Bats Foundation Repair

Subject: Assumption of Engineer of Record Letter  
Project Address: 7002 Teaberry Dr., Austin, TX  
Property Legal Description:

Subject: Post-Repair Foundation Repair Evaluation  
Slab Foundation  
7002 Teaberry Dr., Austin, TX

7002 TEABERRY DR., AUSTIN, TX

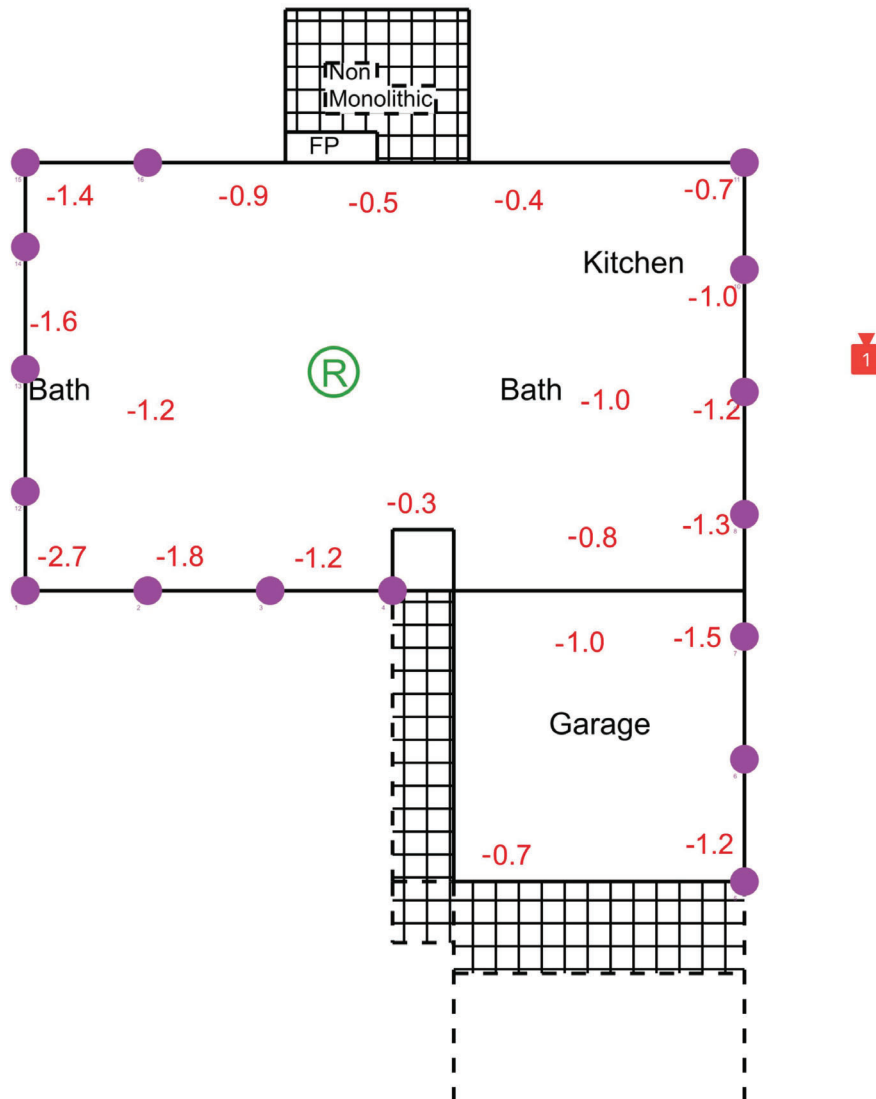
The foundation repair contractor has prepared the attached limited repair plan dated 03/26/25. Based on these documents, it is our opinion that the proposed limited repair plan is reasonable and will mitigate against adverse movement of the foundation in the areas of proposed pier work.

THIS DRAWING IS PROVIDED FOR PRELIMINARY PERMITTING PURPOSES ONLY AND IS A LIMITED PLAN OF REPAIR. ADDITIONAL WORK MAY BE NEEDED ONCE THE FOUNDATION WORK HAS BEGUN BASED ON THE PERFORMANCE OF THIS LIMITED PLAN OF REPAIR. CROSTOWN ENGINEERING HAS PROVIDED REVIEW OF THIS LIMITED PLAN OF REPAIR AND IT IS OUR OPINION THAT IT IS REASONABLE AND SAFE FOR THE STRUCTURE. IF INTERIOR PIERS ARE SHOWN ON THIS DRAWING THE CONTRACTOR WILL PLACE THEM BASED ON THE LOCATIONS OF GRADE BEAMS, PLUMBING LINES AND POST TENSION CABLES, THEREFORE, THE LOCATIONS SHOWN ON THIS MAP ARE APPROXIMATE. THE CONTRACTOR SHALL PROVIDE THE MEANS-AND-METHODS OF THIS INSTALLATION. ADDITIONAL REPAIRS MAY BE REQUIRED UPON REVIEW OF THE STRUCTURE BY CROSTOWN ENGINEERING. THIS IS A PROPOSED SCOPE OF WORK AND HAS NOT BEEN COMPLETED THEREFORE WE DO NOT CERTIFY ANY EXISTING OR PROPOSED FOUNDATION REPAIR WORK ON THIS MAP AT THIS TIME. IF THE READER WOULD LIKE TO BE CERTAIN THAT ANY PROPOSED OR EXISTING REPAIRS HAVE BEEN COMPLETED THEY MUST REQUEST AN ENGINEERING CERTIFICATE FOR THE SUBJECT FOUNDATION WORK FROM THE FOUNDATION REPAIR COMPANY.

#### LIMITED REPAIR PLAN

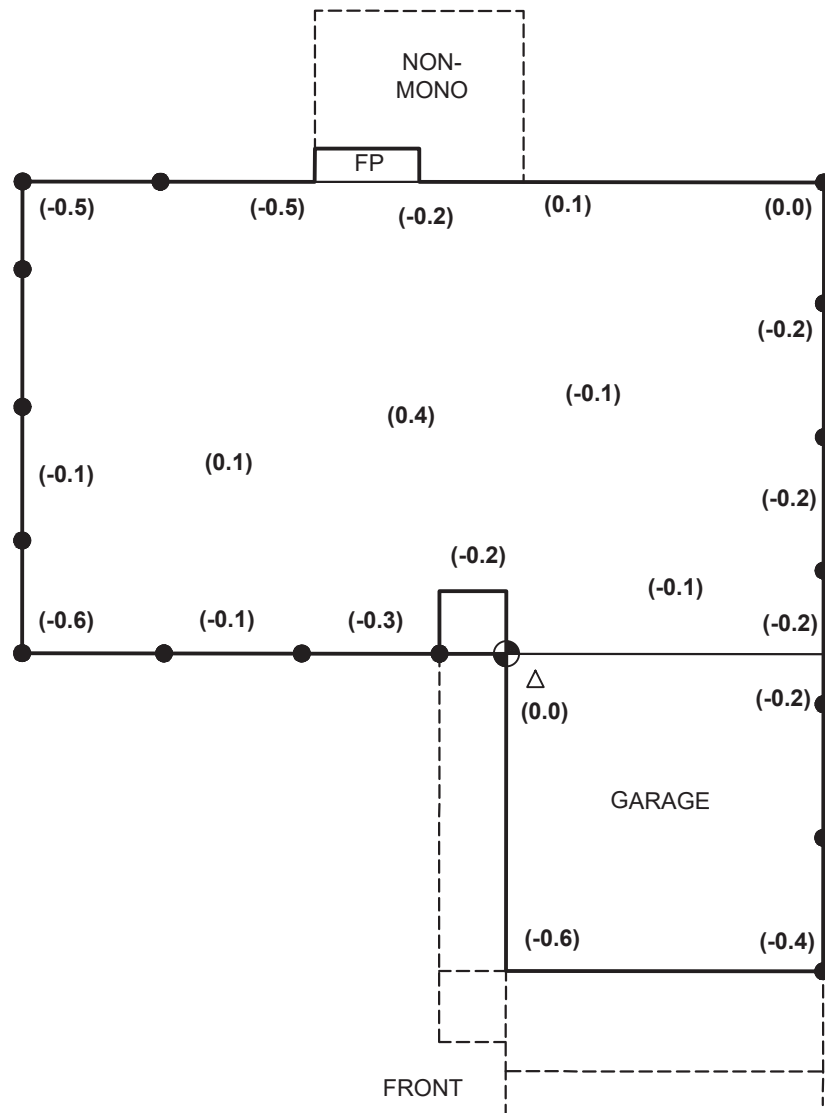
Bats Foundation Repair performed the following in the approximate location of the structure as indicated on the limited repair plan:

- Installed 16 total exterior pilings.
- The piers were driven to an average depth of 7'.

The purpose of the installation was to provide support and mitigate downward movement in the areas of the installation. The foundation repairs meet or exceed the 2021 IRC. To the best of our knowledge the contractor has performed the limited repairs in substantial conformance with their provided limited repair plan and our pre-repair report dated 04/10/25, including any approved changes.
